Planning & Development Consultants

RESPONSE TO THE SUBMISSION OF SIGNIFICANT FURTHER INFORMATION AS PART OF AN EXISTING THIRD PARTY PLANNING OBJECTION IN RESPECT OF A PLANNING APPLICATION IN THE AREA OF DUBLIN CITY COUNCIL, REG. REF. 2683/21. THE DEVELOPMENT CONSISTS OF THE CO PERMISSION FOR DEVELOPMENT AT A SITE (C.039HA) AT GLENAVON HOUSE, 46 BALLYMUN ROAD, GLASNEVIN, DUBLIN 9. THE SUBJECT SITE IS GENERALLY BOUNDED TO THE WEST BY BALLYMUN ROAD AND CLONMORE COURT APARTMENTS, TO THE NORTH BY GLENAVON COURT AND HILLCREST COURT APARTMENTS, TO THE EAST BY THE REAR GARDENS OF HOUSES ON ST. MOBHI ROAD, AND TO THE SOUTH BY MOBHI COURT APARTMENTS AND HOUSES AT THE HAVEN. THE DEVELOPMENT WILL CONSIST OF THE CONSTRUCTION OF A 5 TO 6 STOREY APARTMENT BUILDING (TOTAL GFA C.5,330 SQM EXCLUDING CAR PARK), PARTIALLY OVER BASEMENT, ACCOMMODATING 52 NO. RESIDENTIAL UNITS (13 NO. 1-BED APARTMENTS, 9 NO. 2-BED APARTMENTS, 17 NO. 2-BED DUPLEX APARTMENTS, 8 NO. 3-BED APARTMENTS AND 5 NO. 3-BED DUPLEX APARTMENTS), ALL WITH PRIVATE BALCONIES ON THE EAST OR WEST ELEVATION (ETC). 1 NO. CAR SHARE SPACE AT SURFACE LEVEL. 37 NO. CAR PARKING SPACES AT BASEMENT. 80 NO. BICYCLE PARKING SPACES. ESB SUBSTATION A

Fig. 14: Fourth/Fifth storey floor plan relative to client properties on St. Mobhi Road & their rear gardens

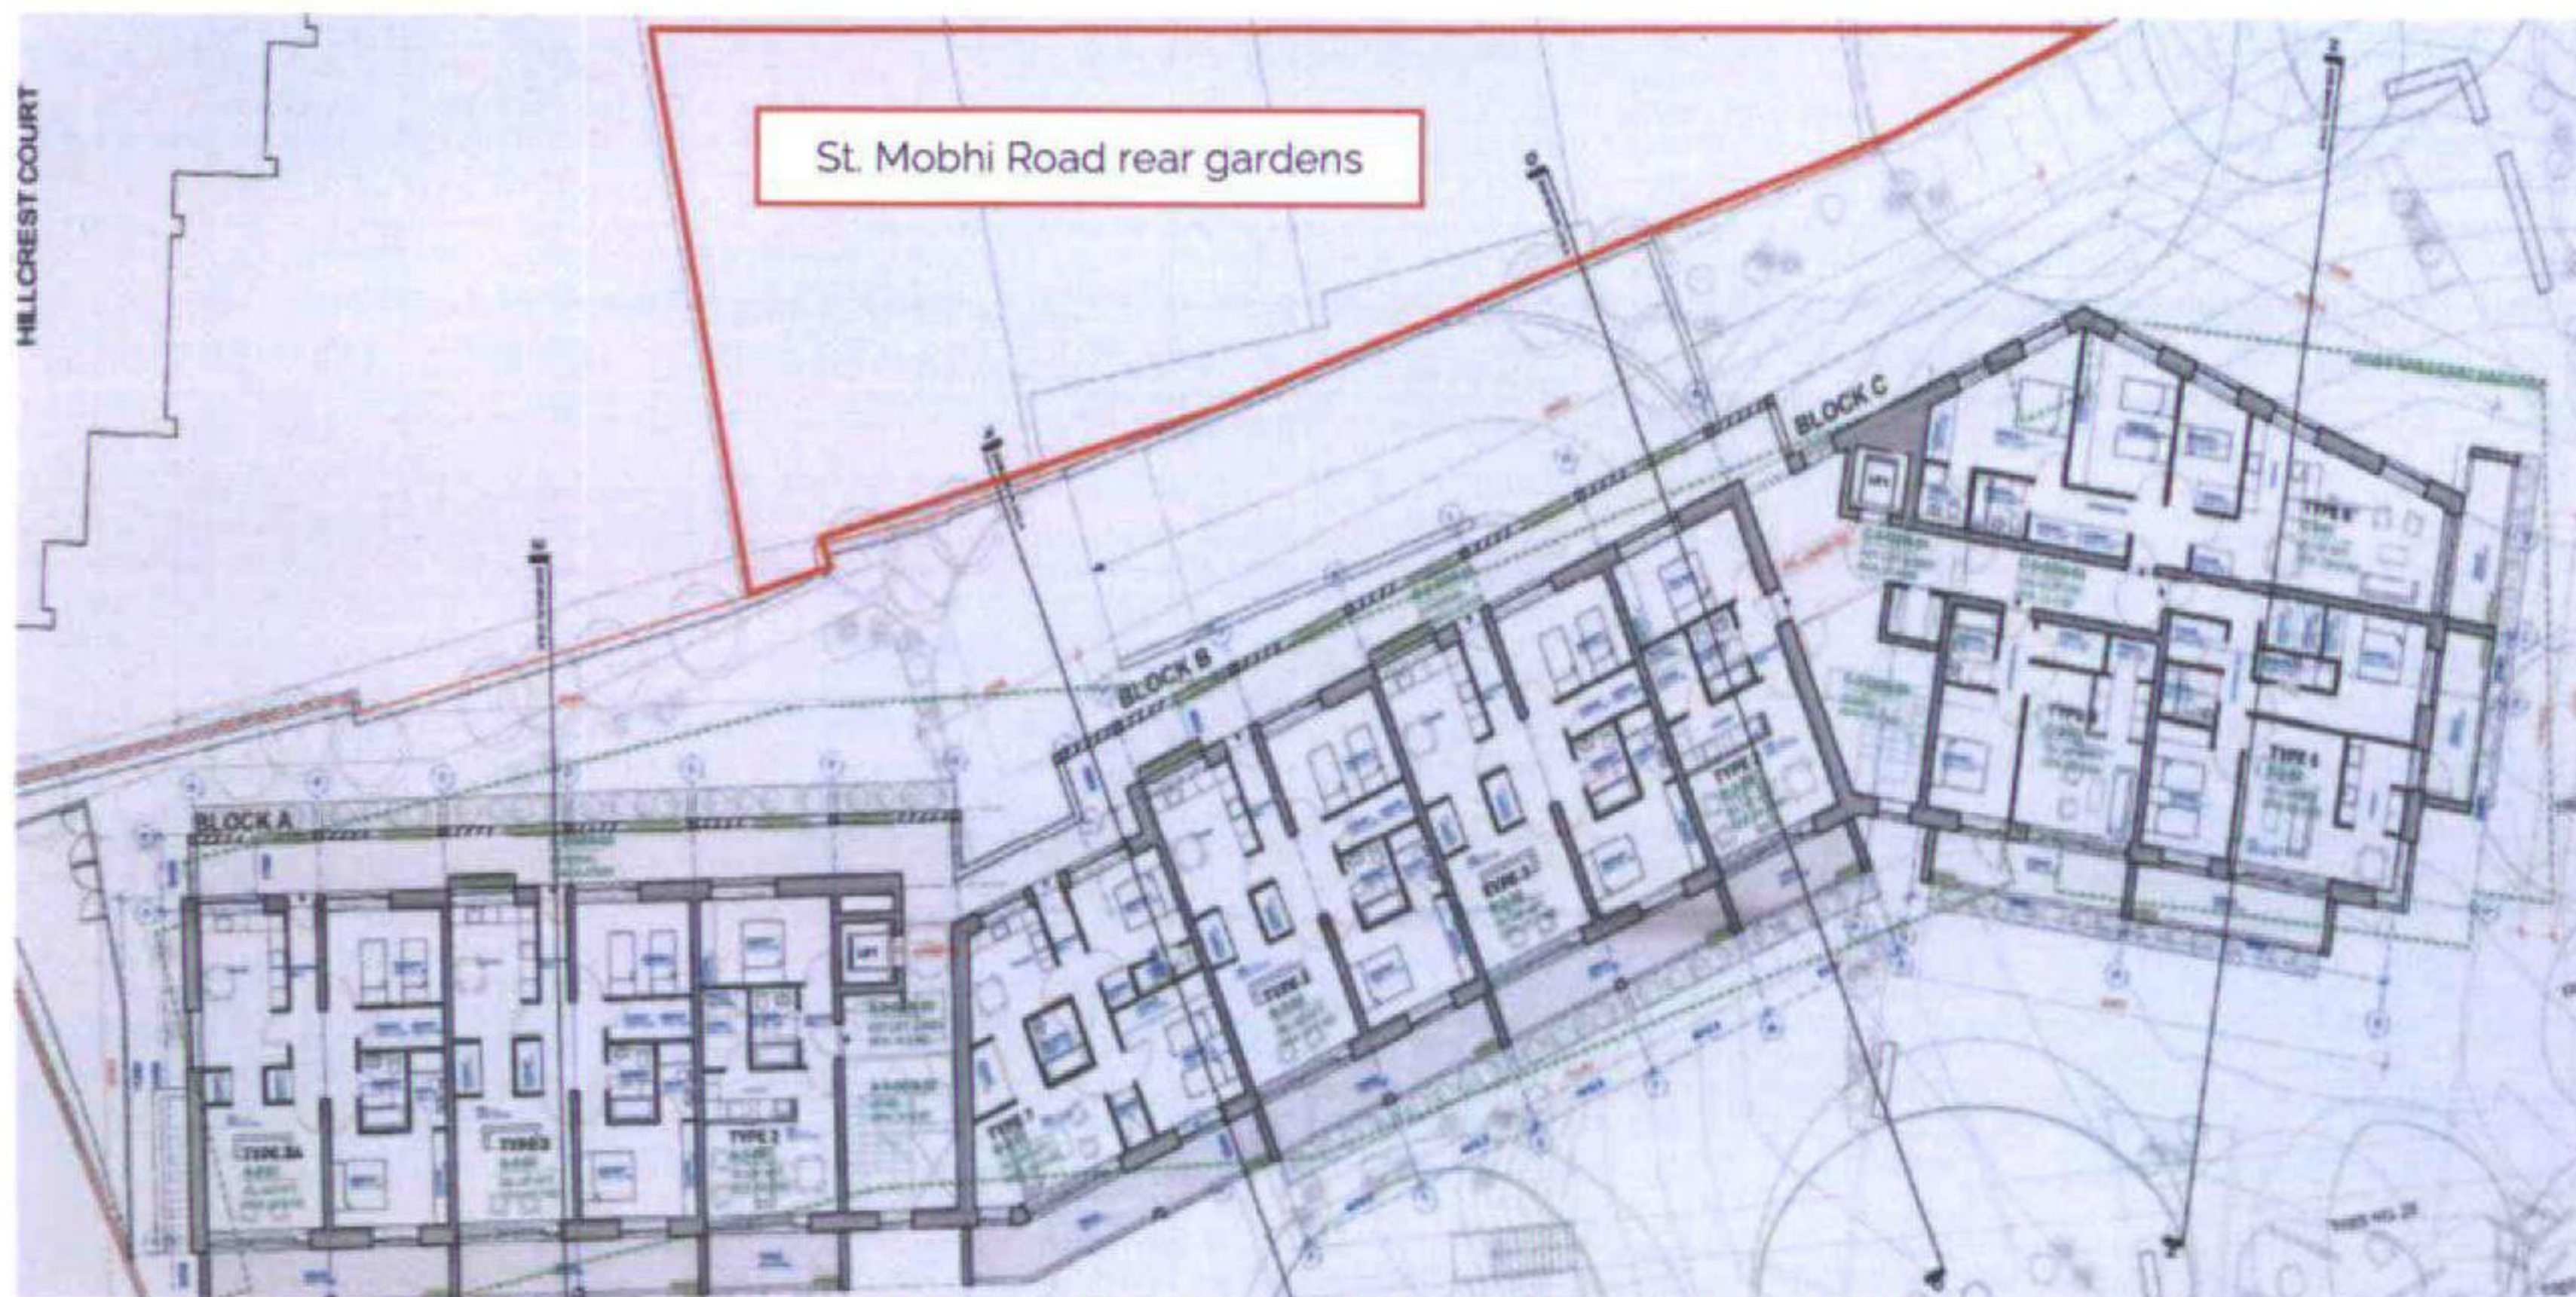
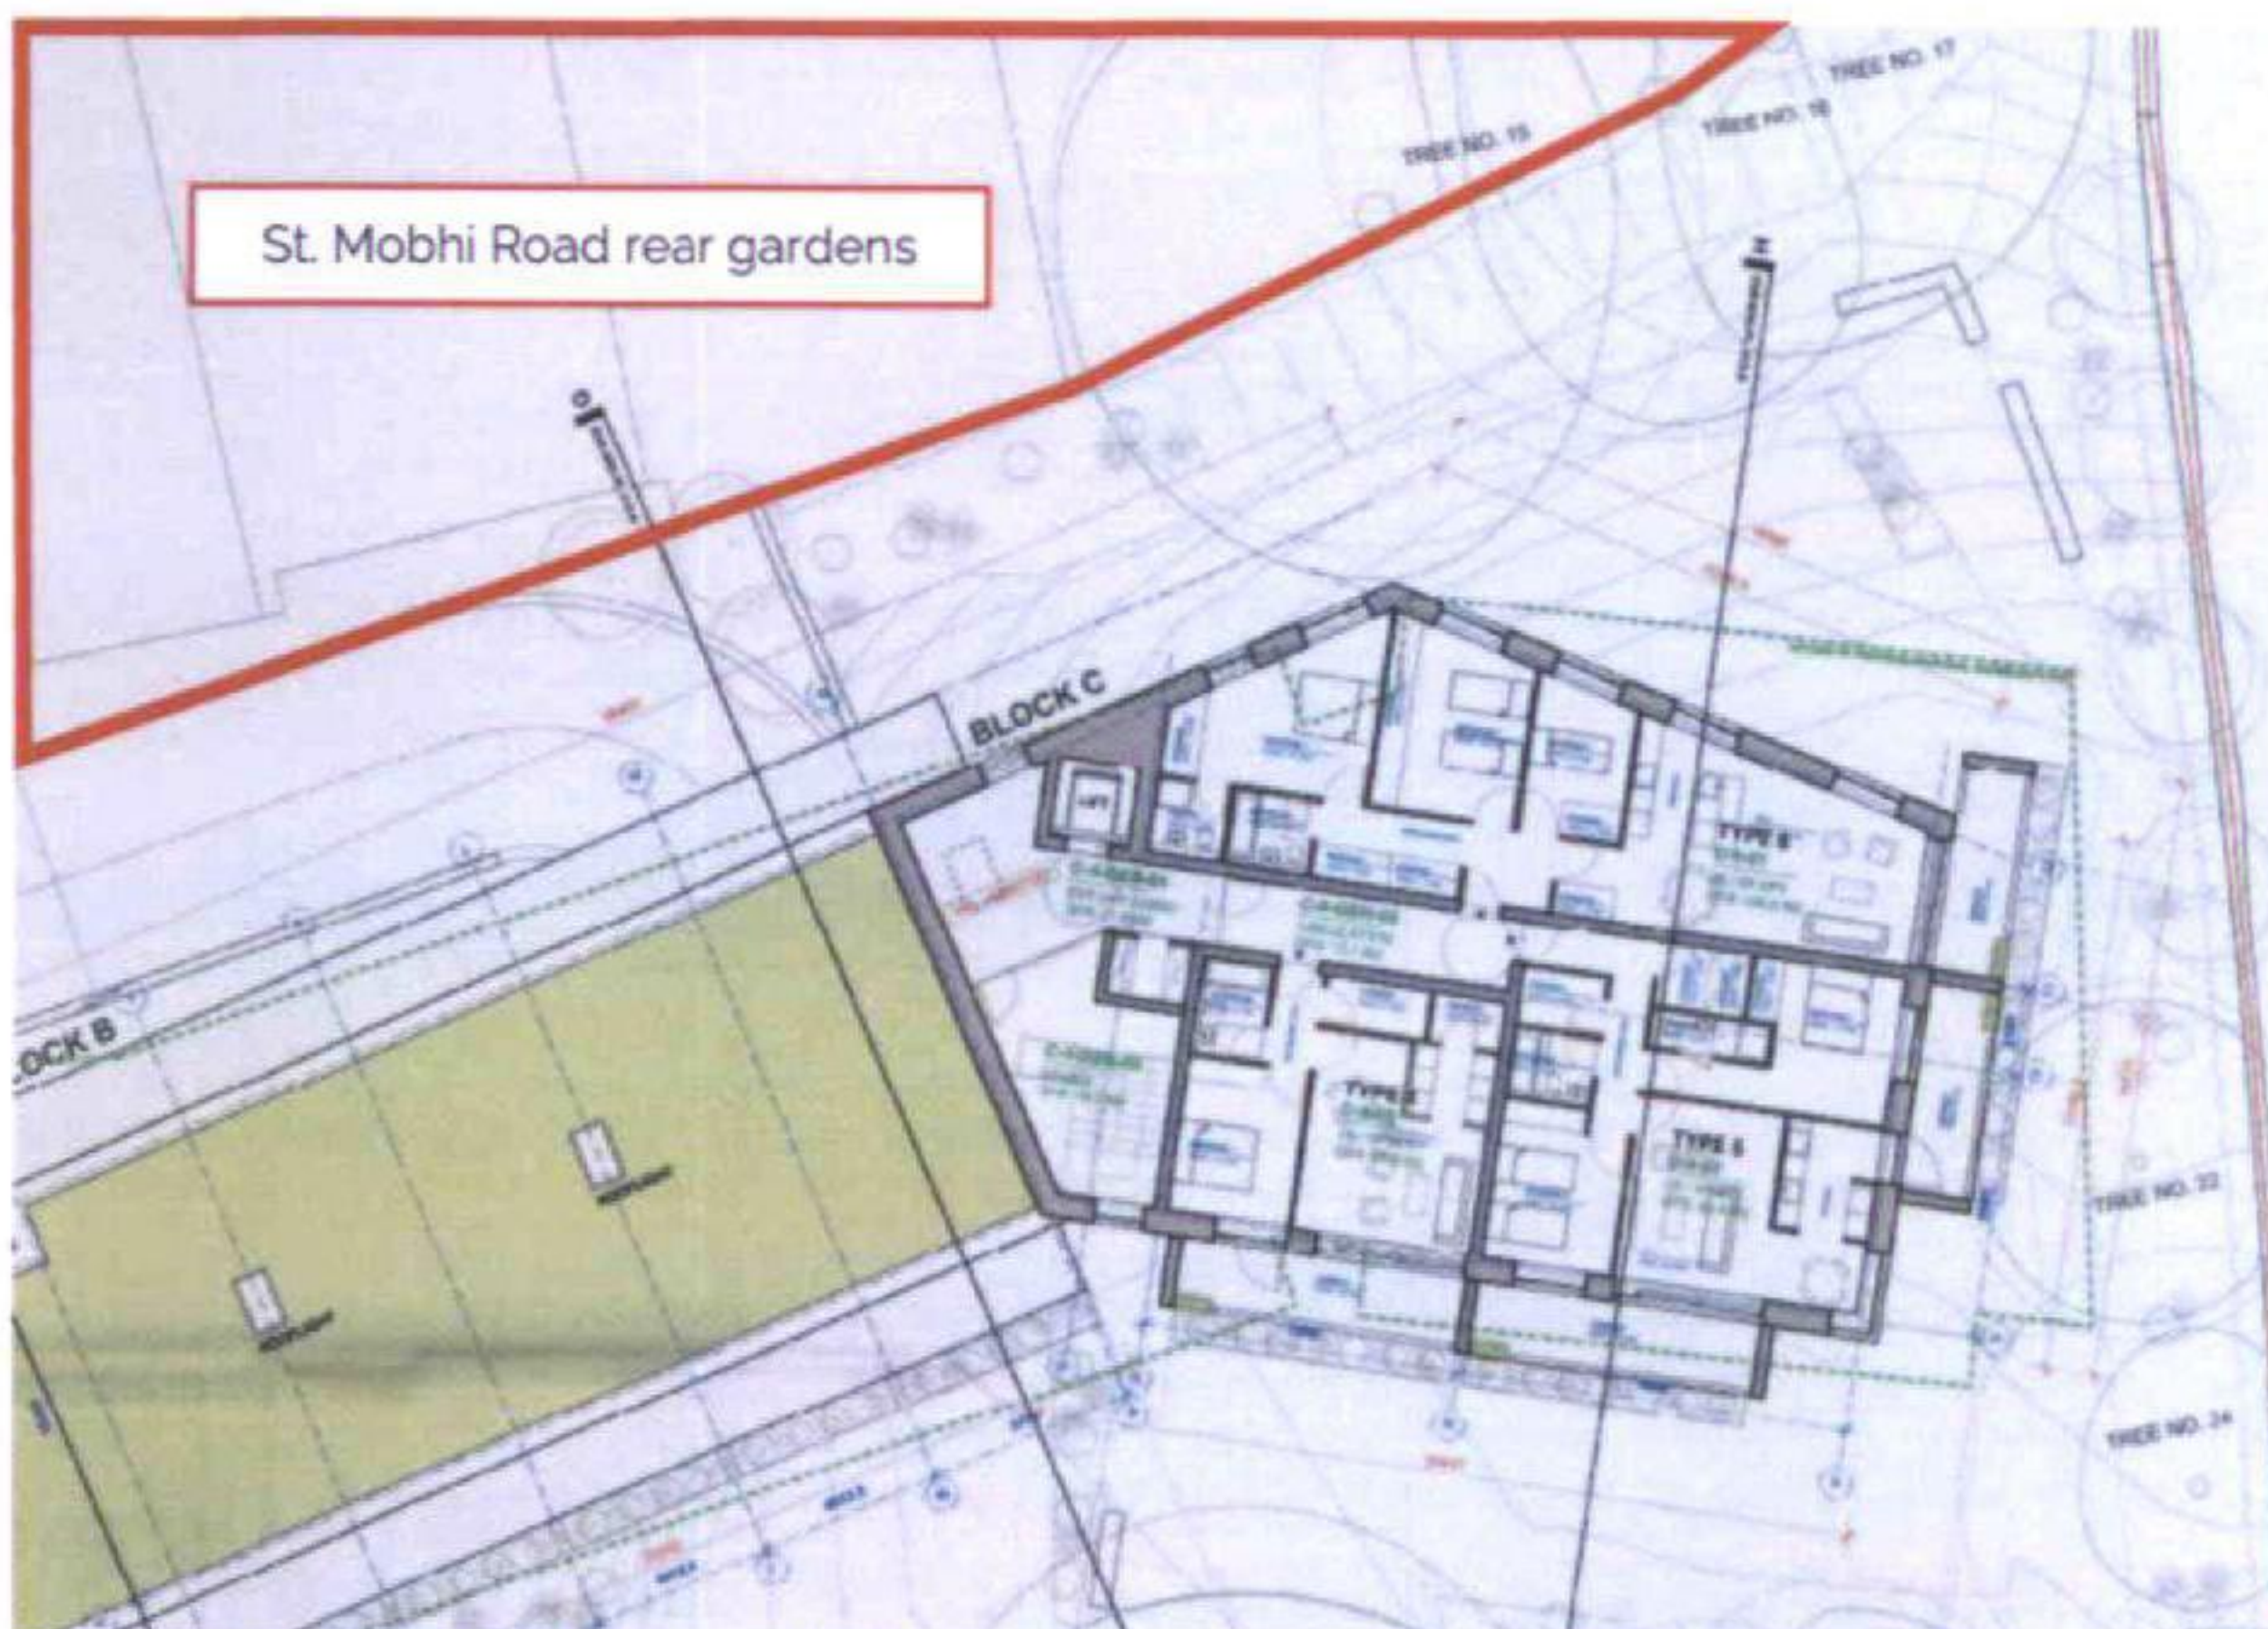
2. **Claims to provide greater separation distances to the eastern boundary require review.** The Applicant repeats the claim that the building is setback further in the SFI scheme than it was originally. Figs. 12 and 13 of this letter show that this is not the case for Blocks B and C. Blocks B and C are closer or setback to the same extent as they were originally. Block B remains partly a 5 story building while Block C remains a fully 6 storey building.
3. **No additional mitigation and/or screening measures are introduced to address significant overlooking arising.** Our clients' concerns as to direct overlooking from Blocks A, B and C are not addressed. Concerns over the perception of overlooking are not addressed and the measures that purportedly offer screening to mitigate overlooking serve to increase the bulk of the building as it faces our clients' properties.

Fig. 16: SFI contiguous elevation shows areas of overlooking concern

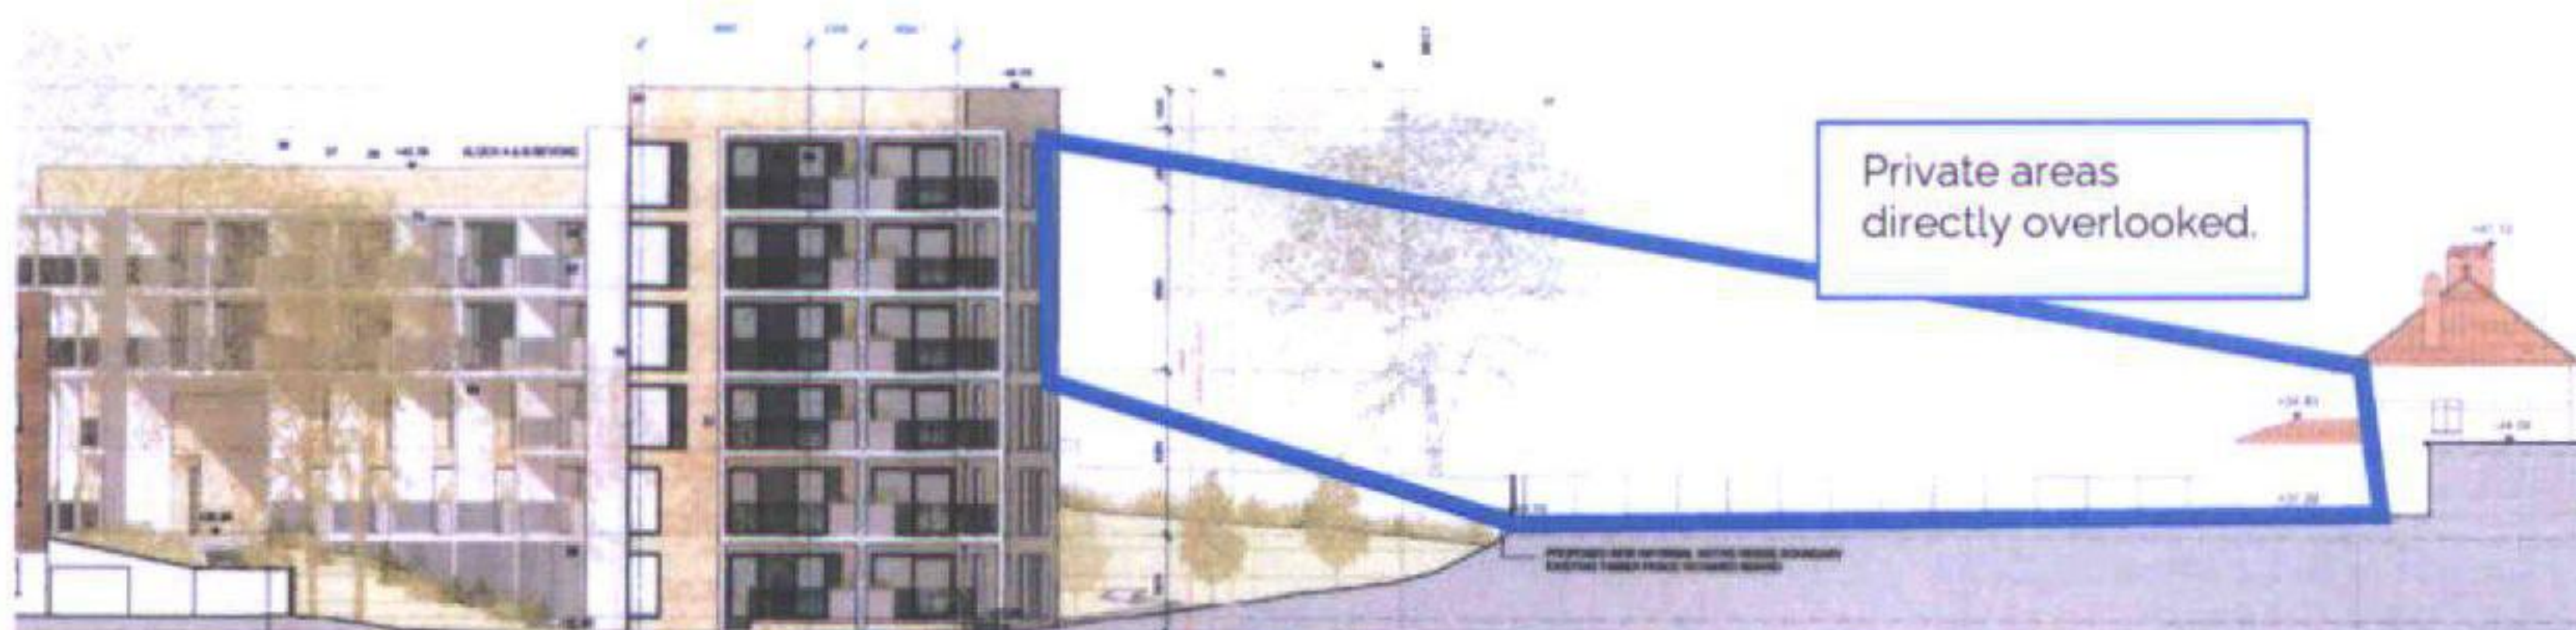
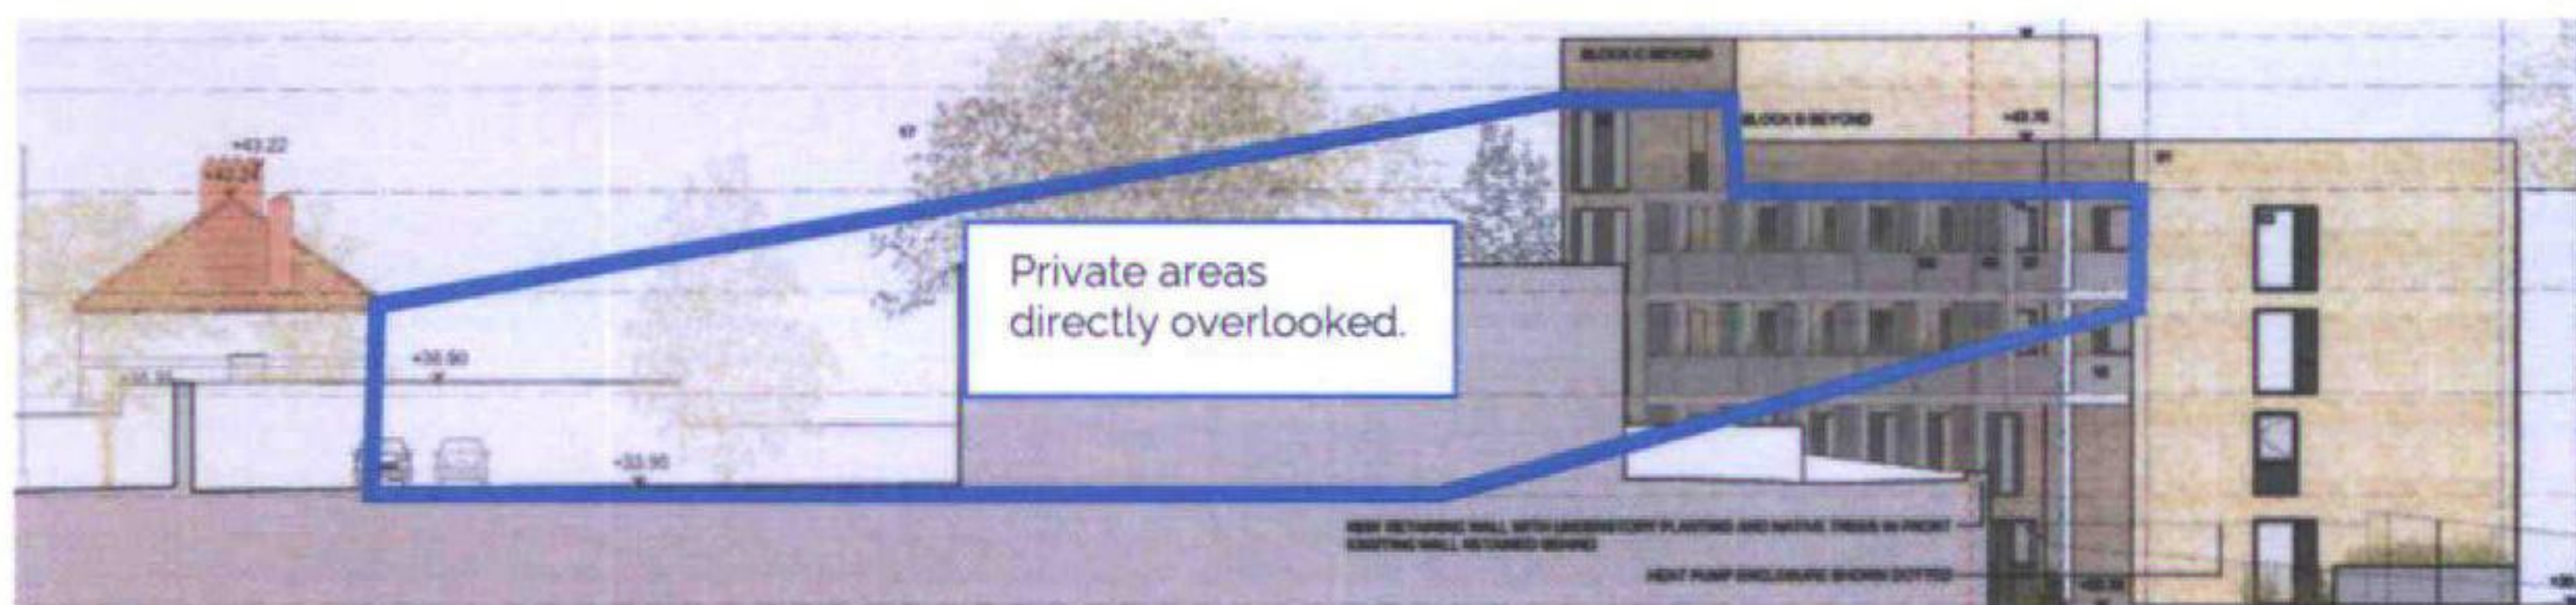
Our clients ask that DCC re-evaluate the extent of overlooking arising and ask the Applicant to furnish photographs taken from levels 4, 5 and 6 of the achievable views of their properties including their private rear gardens. Their preference is for the scheme to be reduced to 3 storeys with the building dropping in height along the contours of the site from north to south. They accept that a 3 storey building will cause some overlooking but they do not find 4, 5 and 6 storeys to be acceptable from an overlooking perspective as they would cause significant negative overlooking from high levels.
